INTERNATIONAL TORNADO CLASS

The following amendments to the Class Rules have been approved to be effective 28 October 2016:

APPENDIX D: Mainsail Identification

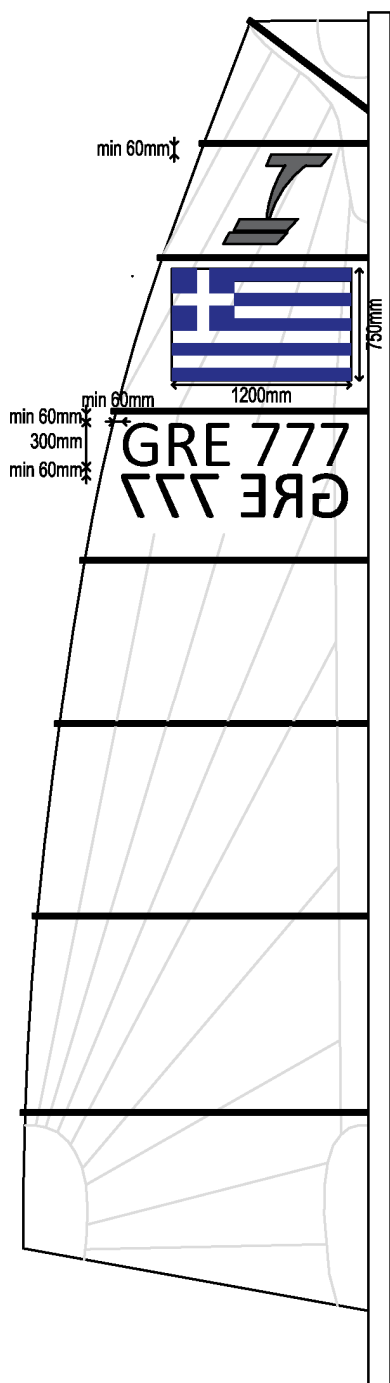
- (1) The Class insignia, national letters and sail numbers shall comply with the RRS Appendix G except where specified otherwise below and in Appendix D of these **class rules**.
- (2). The Class insignia, National Flag (when applicable) and Sail Letters and Numbers shall be placed in the following locations below the head point;

8 batten mainsail	9 batten mainsail
Class Insignia	3 rd panel	4 th panel
National Flag	4 th panel	5 th panel
Sail Numbers & Letters	5 th panel	6 th panel

- (3) The Class insignia specified in Class Rule Appendix D shall be placed back to back with the ‘tail’ aft and a minimum of 60mm below the batten pocket. This amends RRS Appendix G1.3(b).
- (4) The national letters and numbers which are on the same side of the sail shall be placed on the same line, a minimum of 60mm below the batten pocket, and a minimum of 60mm from the leech. This amends RRS Appendix G1.3(c).

- (i) At the International Tornado Class World Championship and Continental Championships the national flag corresponding to the national letters shall be placed on the starboard side of the mainsail on the panel specified in C.10.3(a)(ii). The national flag is optional at all other events. The flag shall be nominally 1200mm wide x 750mm high, positioned approximately central on the panel
